FOREST LAKES FILING NO. 7

CONSTRUCTION PLANS

PCD FILE # SF-21-49

FOREST LAKES FILING NO. 7
CONSTRUCTION PLANS
PUBLIC STORM SEWER PLAN
'MAIN A'/'MAIN B'/'MAIN B' LATERALS 1-2'

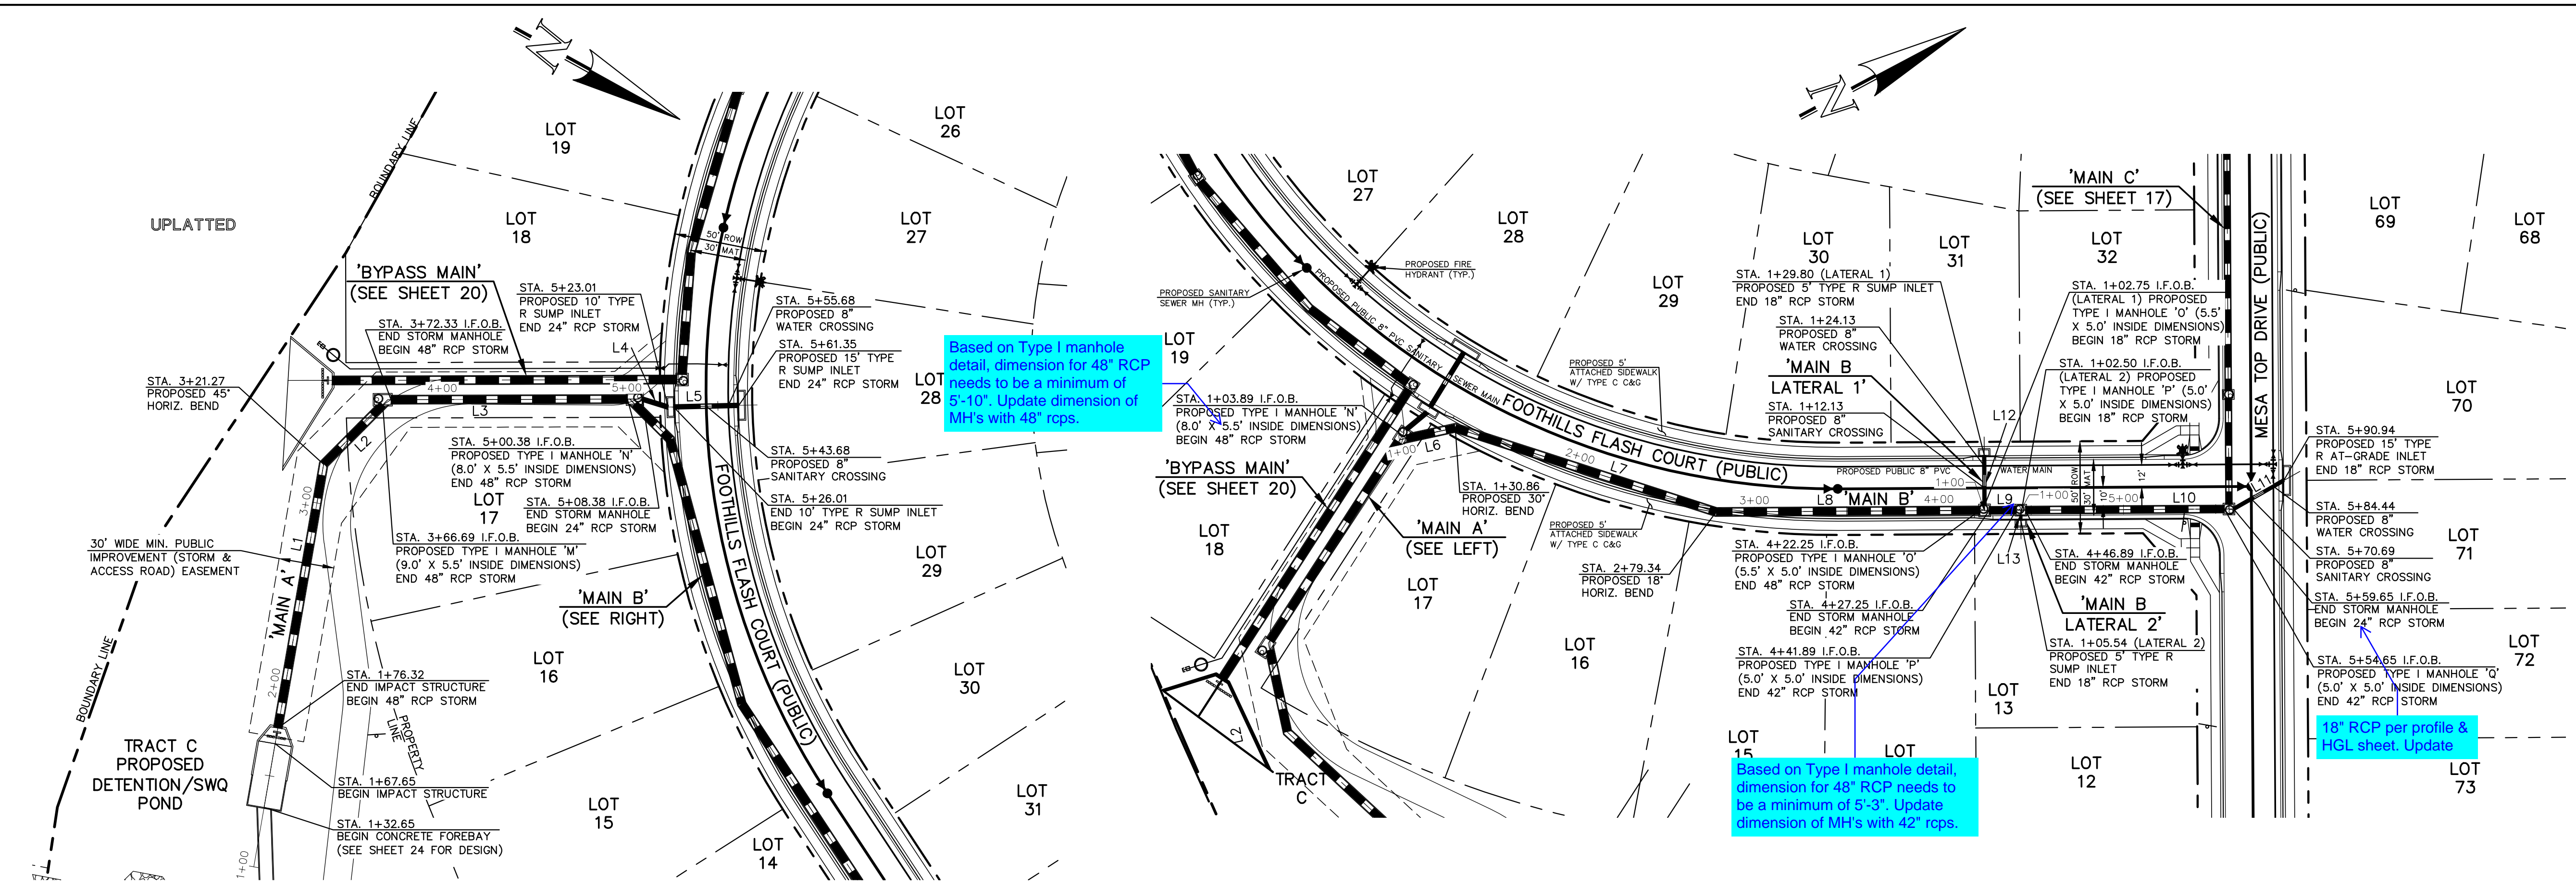
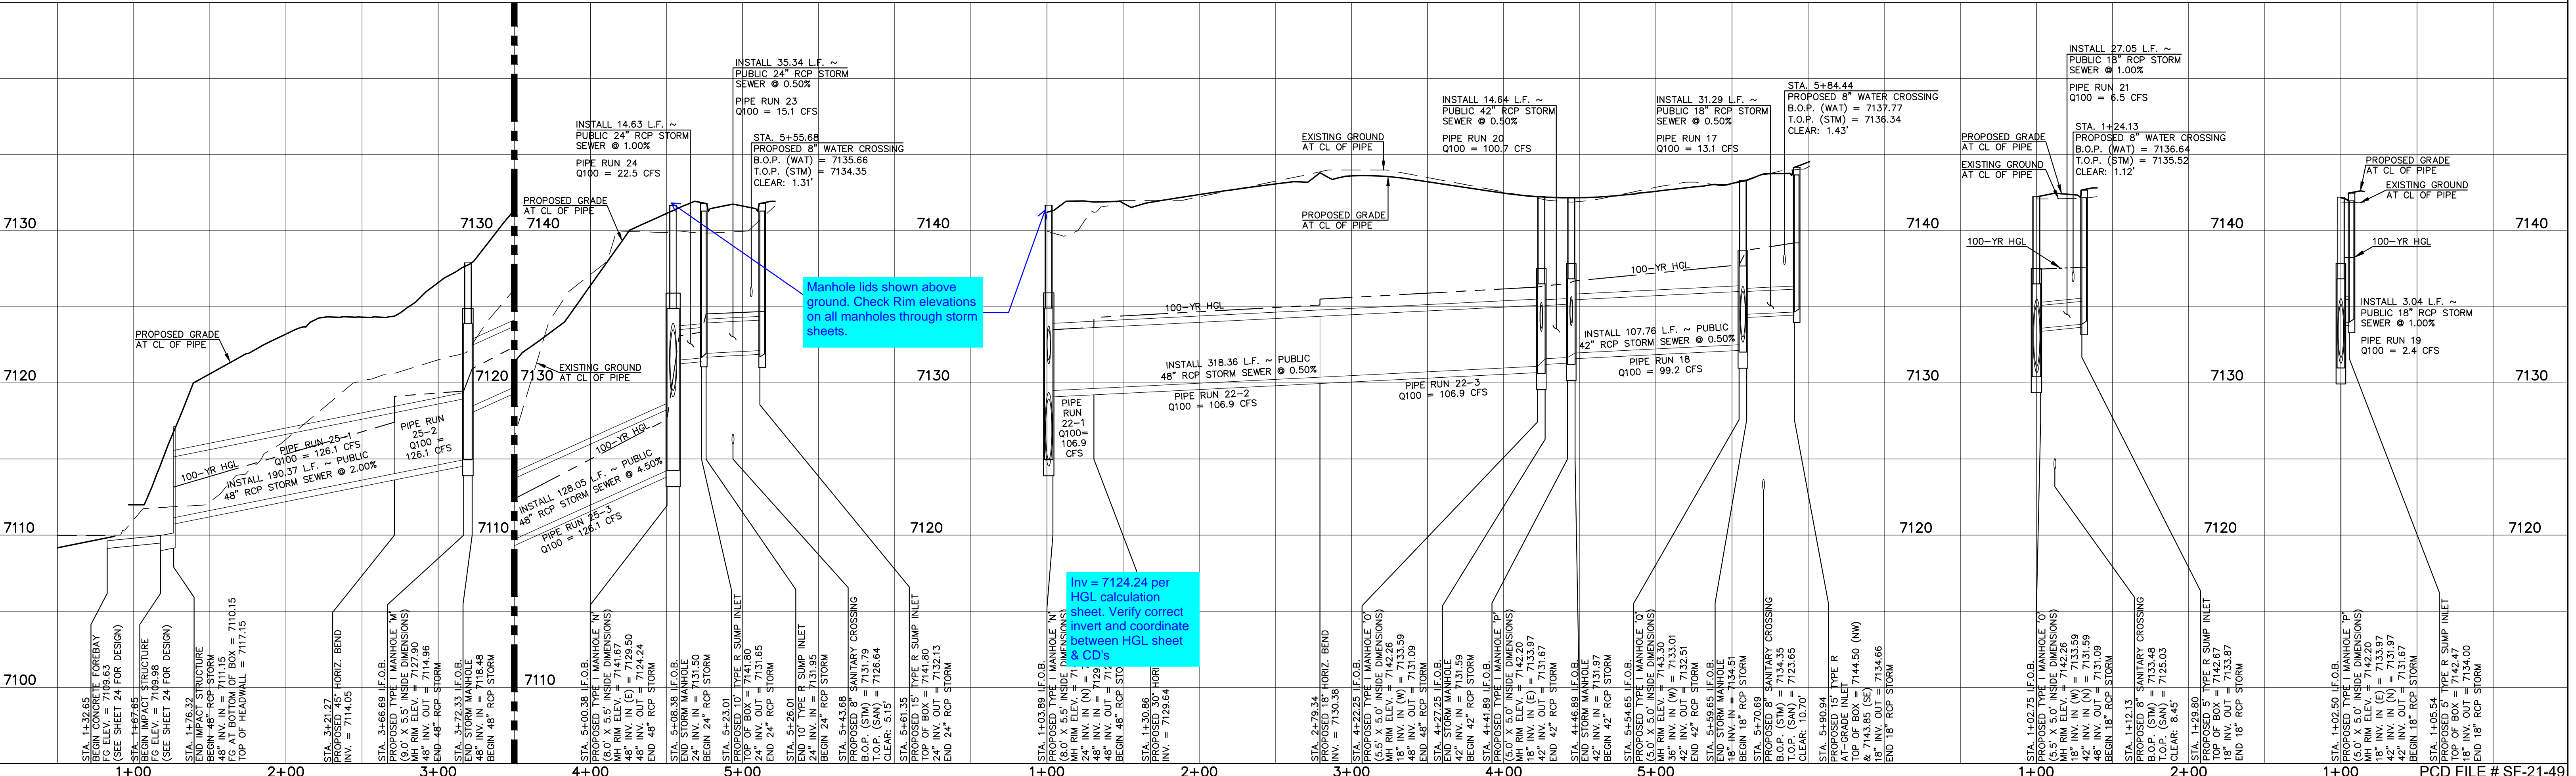
Add note or pipe labels that storm pipes are Class 3, except for those with velocity in excess of 18 fps, and those shall be Class 4.

Manhole lids shown above ground. Check Rim elevations on all manholes through storm sheets.

Inv = 7124.24 per HGL calculation sheet. Verify correct invert and coordinate between HGL sheet & CD.

FOREST LAKES FILING NO. 7
CONSTRUCTION PLANS
PUBLIC STORM SEWER PLAN
'MAIN C' / 'MAIN C LATERALS 1-3'
DESIGNED BY: MAL SCALE: (H) 1" = 50' DATE: 06/01/21
DRAWN BY: MES (V) 1" = 5' SHEET 17 OF 31
CHECKED BY: DATE: JOB NO. 1175.70

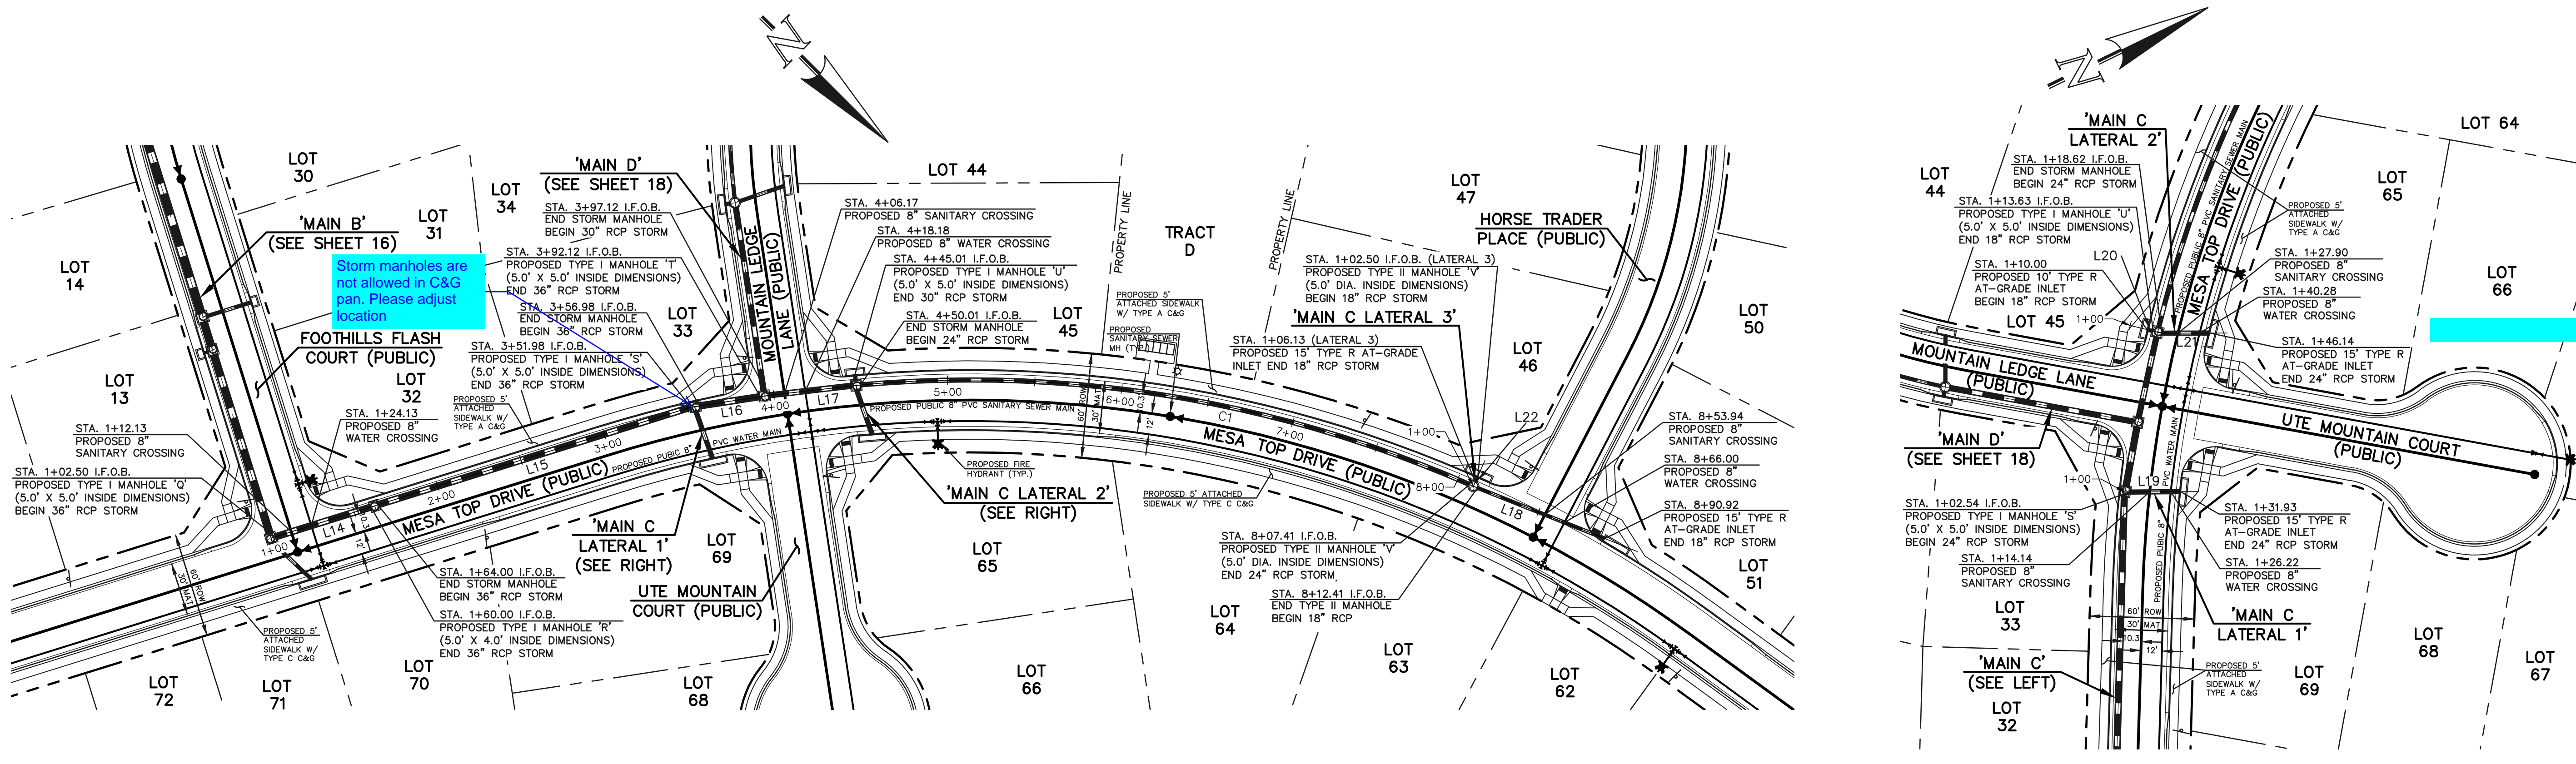
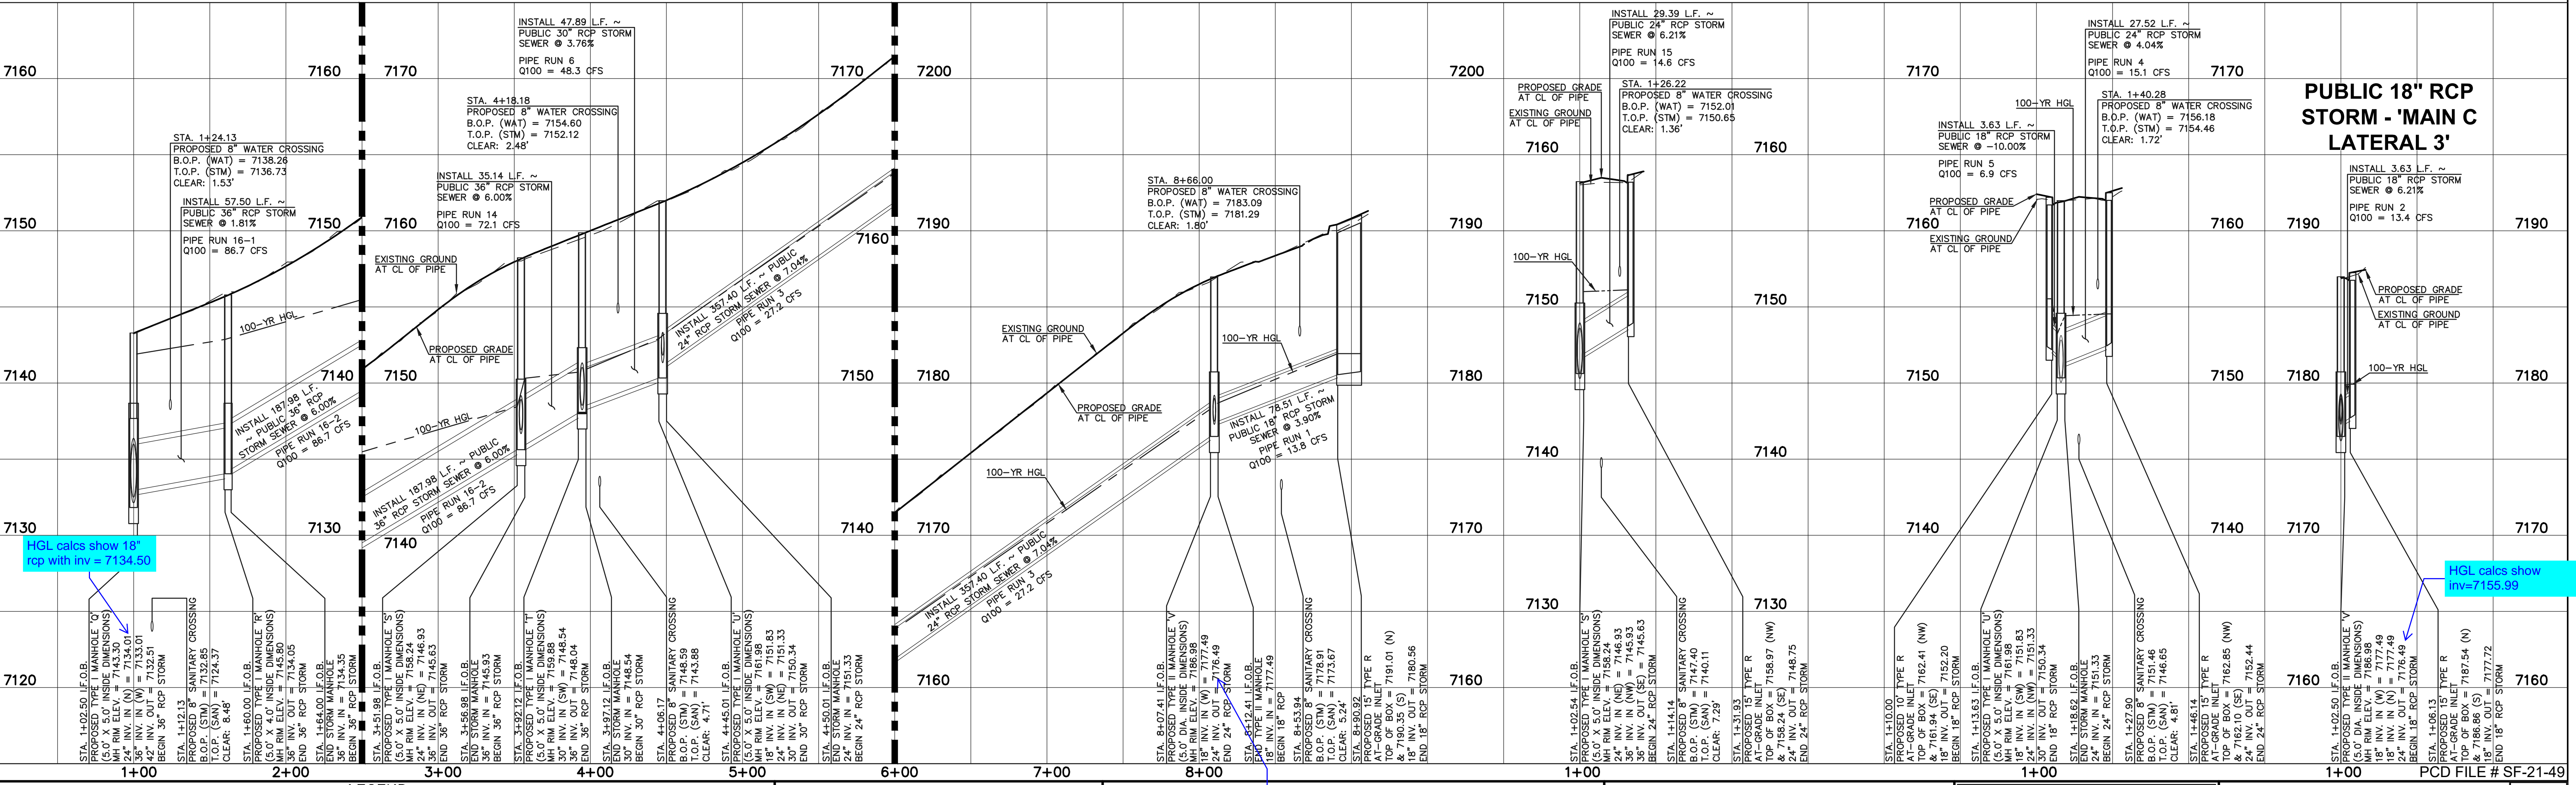
HGL calcs show 18" rcp with inv=7134.50

HGL calcs show inv=7155.99

NO.	REVISION	DATE
	HGL calcs show inv=7155.99
